**SimplexGrinnell #458 & JCI
9520 10th Avenue South, Suite 100
Seattle, WA 98108
RE: Western State Hospital; Lakewood, WA
400,000 Gallon STP
August 4, 2018
Ms. Melissa Fraser
Systems Integrity Representative
(206) 291-1439
Job No. 318298-B**

STANDPIPE INSPECTION REPORT

JOB NO: 318298-B INSPECTOR: Christian Costello (LJ)
TANK OWNER: Western State Hospital
OWNER'S REPRESENTATIVE: SimplexGrinnell #458 & JCI; Ms. Melissa Fraser
TITLE: Systems Integrity Representative
MAILING ADDRESS: 9520 10th Avenue South, Suite 100, Seattle, WA 98108
PHYSICAL ADDRESS: 9520 10th Avenue South, Suite 100, Seattle, WA 98108
E-MAIL: Melissa.fraser@jci.com
CITY, STATE: Seattle, WA ZIP: 98108 COUNTY: Pierce County
TELEPHONE: (206) 291-1439 FAX: (206) 291-1500
LOCATION OF TANK: Western State Hospital; 9601 Steilacoom Blvd. SW, Lakewood, WA 98498

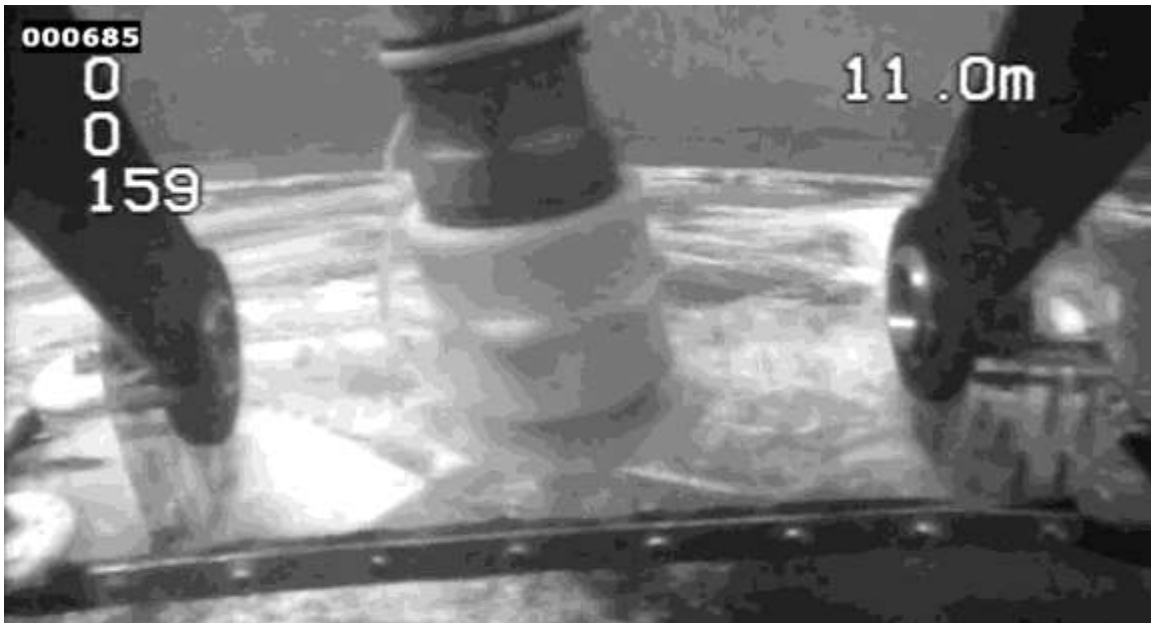
Photos show the tank exterior coating system. We recommend pressure washing the tank exterior with biodegradable detergent injection (minimum 3,500 psi at 3.0 gpm) then removing all loose rust and scale with wire brushes and hand scrapers in accordance with SSPC#2 (hand tool cleaning), spot priming and applying one (1) finish coat of acrylic paint.

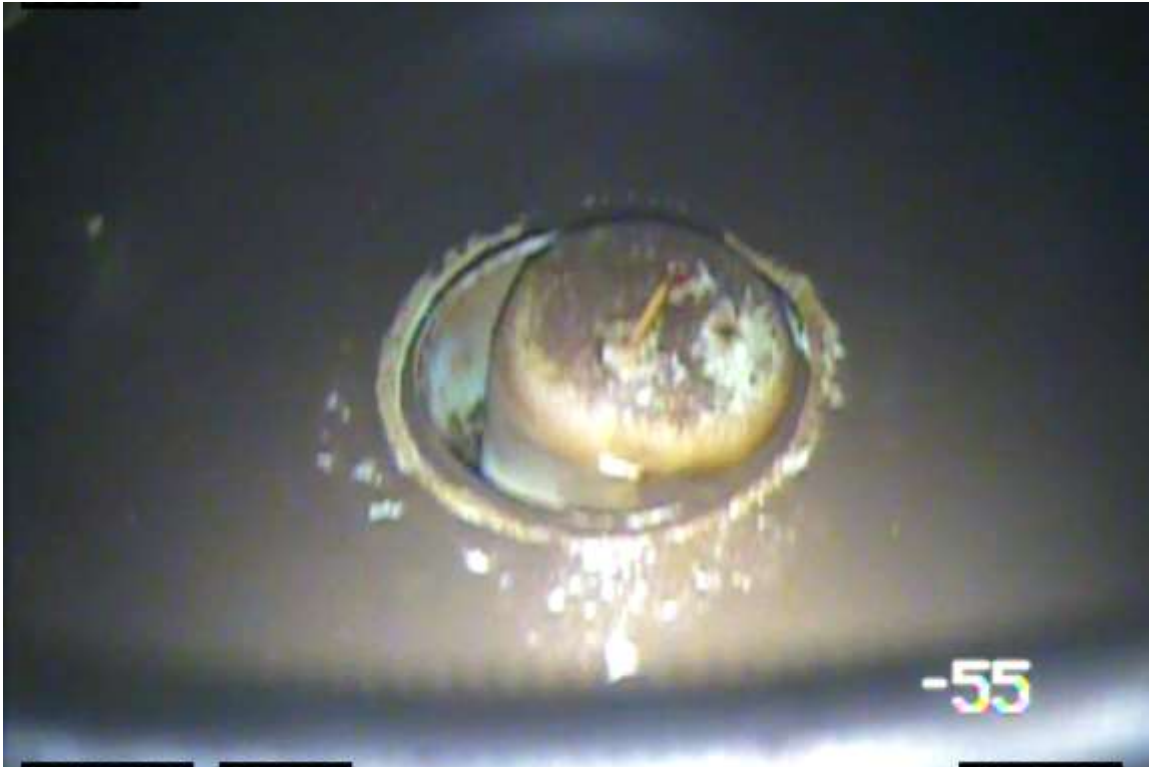
Top photo shows the condition of the interior roof. Notice the rust forming at the roof lap seams. We recommend seam sealing using Sikaflex® 1a on all unwelded interior roof lap seams to prevent failure of a new interior liner. This work is to be performed in conjunction with application of new interior liner.

Bottom photo shows the condition of the interior roof-to-rim angle connection. Notice the rust forming in the crevice between the roof and rim angle. We recommend seam sealing using Sikaflex® 1a around the circumference of this connection to prevent failure of a new interior liner. This work is to be performed in conjunction with application of new interior liner.
